Letter CA: Janet McKibben (January 9, 2021)

RE: Opposition to SE-PLR-2 Templeton – South River Route *Alternative*

Re: Estrella Substation Project Public Comment

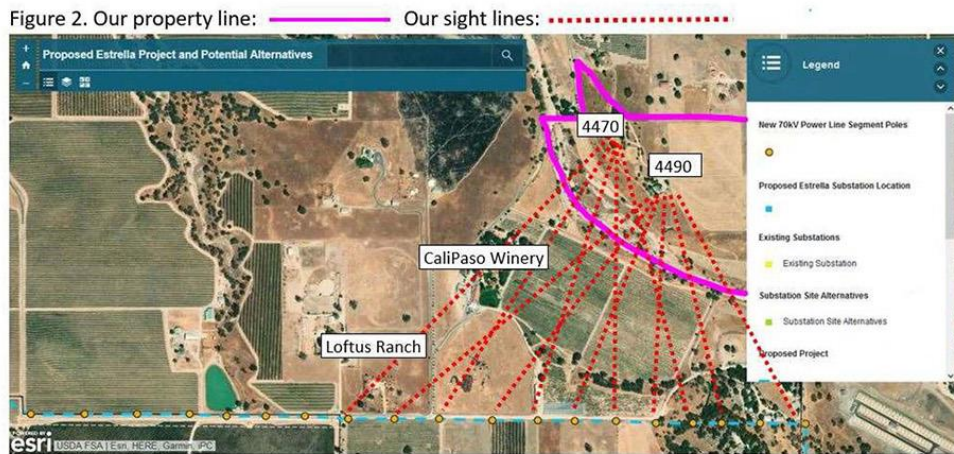
CP-5 | Our home is located at the top of Figure 1, on the next page. Our sight lines are illustrated in Figure 2.

Because our sight lines would run perpendicular to the 70kV line, the proposed route would ruin the southwestward, panoramic view from our home. However, for my family, this isn't just a view, it's the backdrop of our lives.

The comment provides figures showing the location of the commenter's home, the commenter's properties' sight lines, and claims the project will have aesthetic impacts on the commenter's property. This figure provided by the commenter shows that the commenter's property is approximately 0.4 miles north of the Proposed Project 70 kV power line route. It also shows that there is a vineyard, trees, some topography changes, and a creek between the commenter's house and the proposed powerline. These factors reduce the level of impact on this property. Furthermore, as discussed in Master Response 3, CEQA is primarily concerned with a project's effects on public views and not private residential views.
